STATE OF NORTH CAROLINA
DEPARTMENT OF TRANSPORTATION

Addendum No. 1
RE: Contract # C204039
WBS # 34243.3.2
STATE FUNDED
Polk County (I-4729A)
I-26/US-74/NC-108 Interchange Modifications in the Town Of Columbus

September 19, 2017 Letting

The following revisions have been made to the Roadway plans:

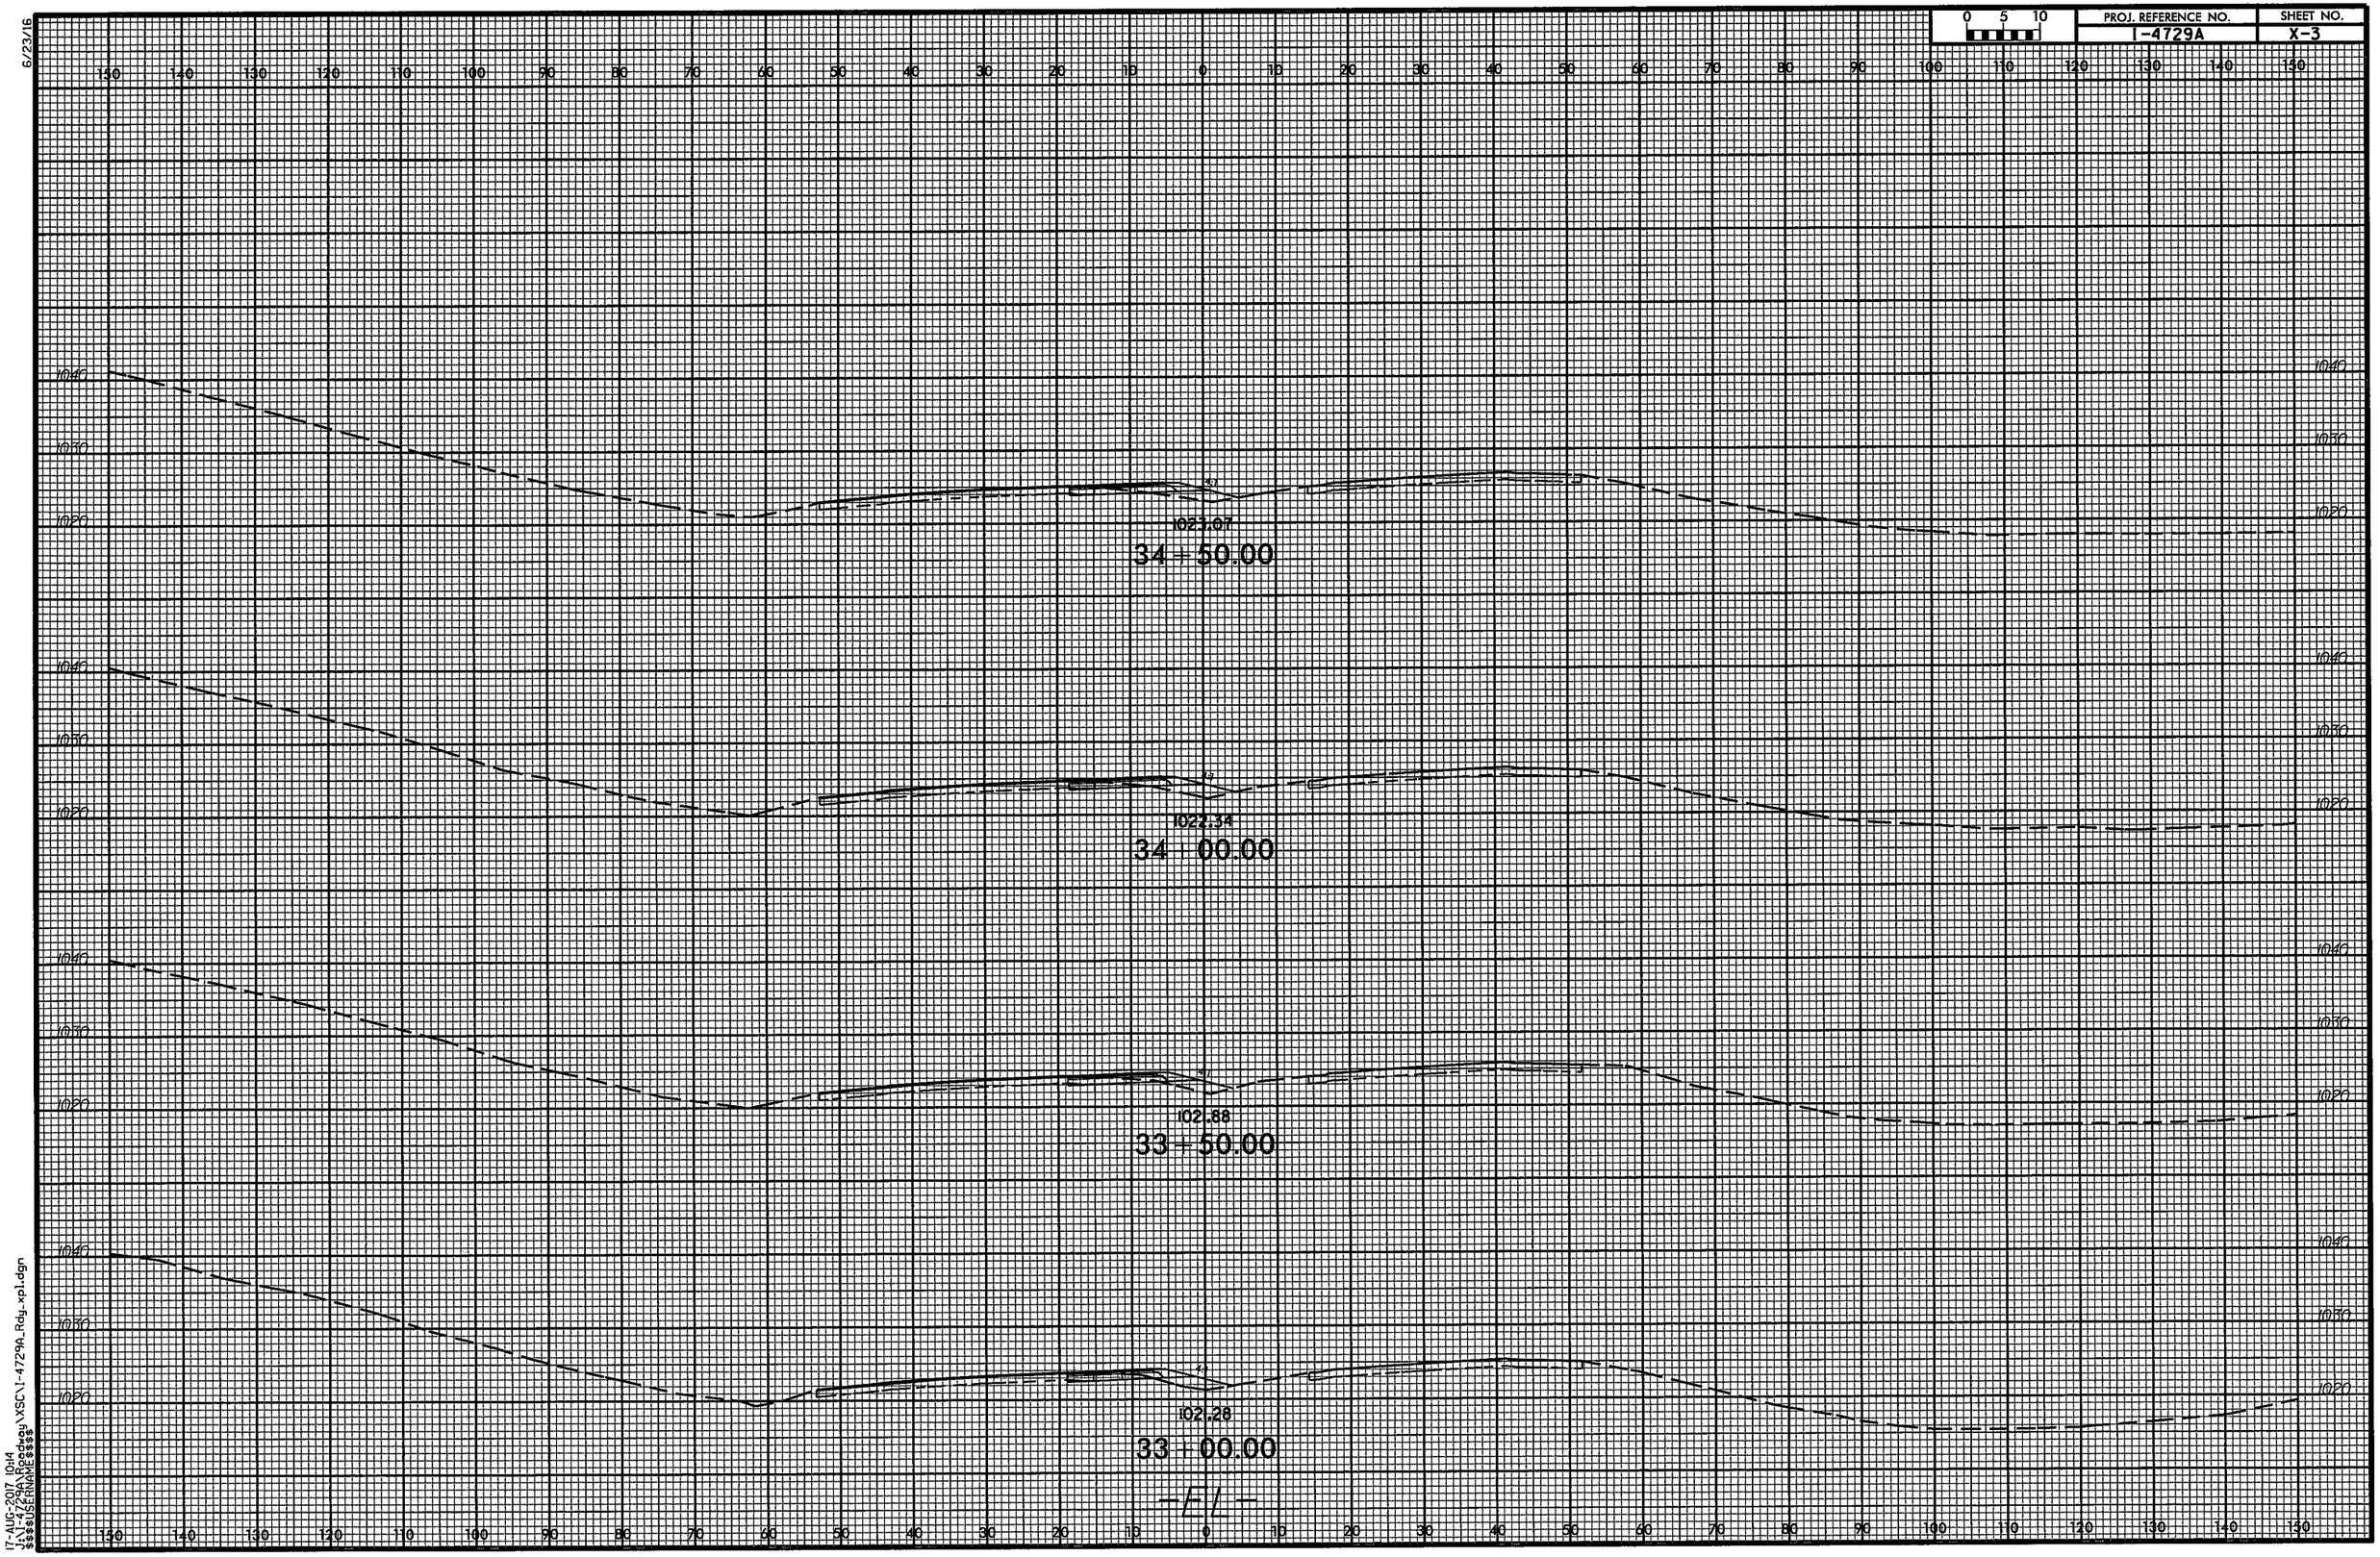
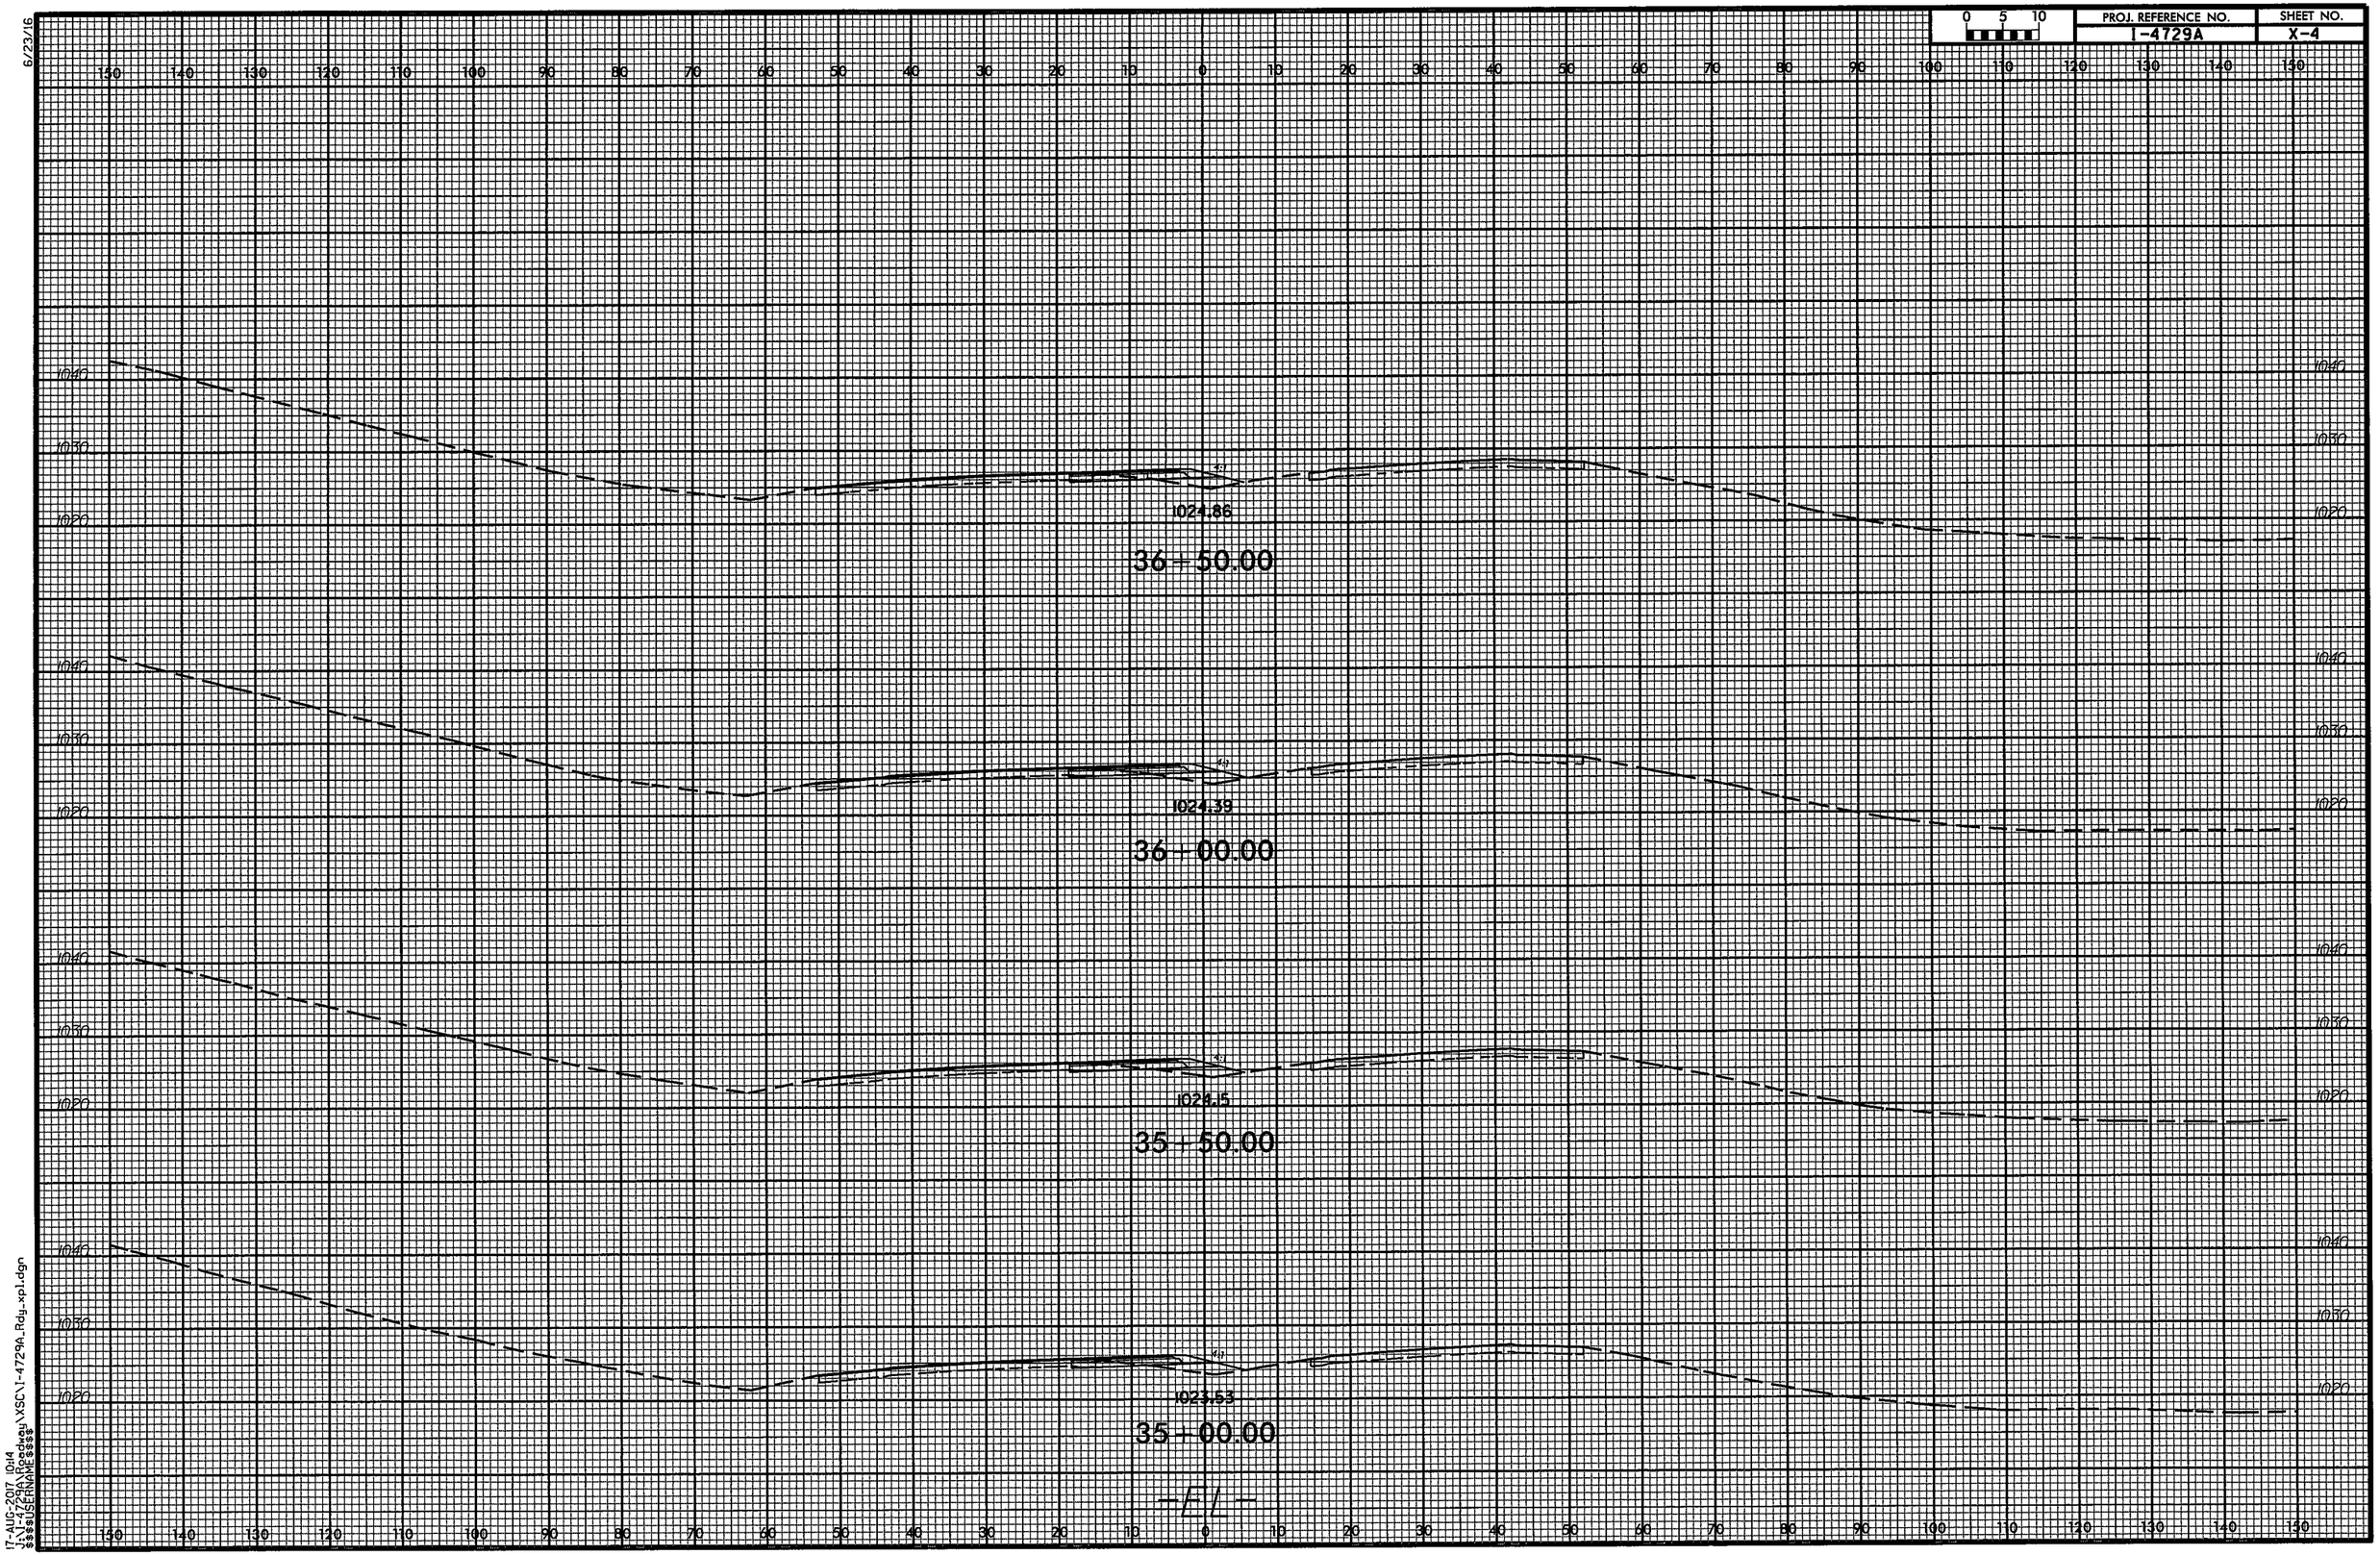
Sheet No.	Revisions
1A	Revised Index of Sheets to remove 2G-2 "Standard Embankment Monitoring Detail" and revise the number of" Drainage Summaries" sheets
2A-1, 2A-4 and 2A-5	Revised the Typical Sections for the change in mainline pavement widening design from ABC to Asphalt Base
3B-1	Revised 'Summary of Earthwork' to account for pavement widening design change
3D-1 thru 3D-4	Various drainage quantity changes as noted below
3G-1	Removed "Settlement Gauge Summary" and added note that Bridge Waiting Period only applies to Approach Slab construction
5	Revised to require Welded Steel Pipe by Trenchless method under the Interstate 26
X-1A thru X-87	Revised Cross-Sections to reflect the change in Earthwork due to the pavement design change
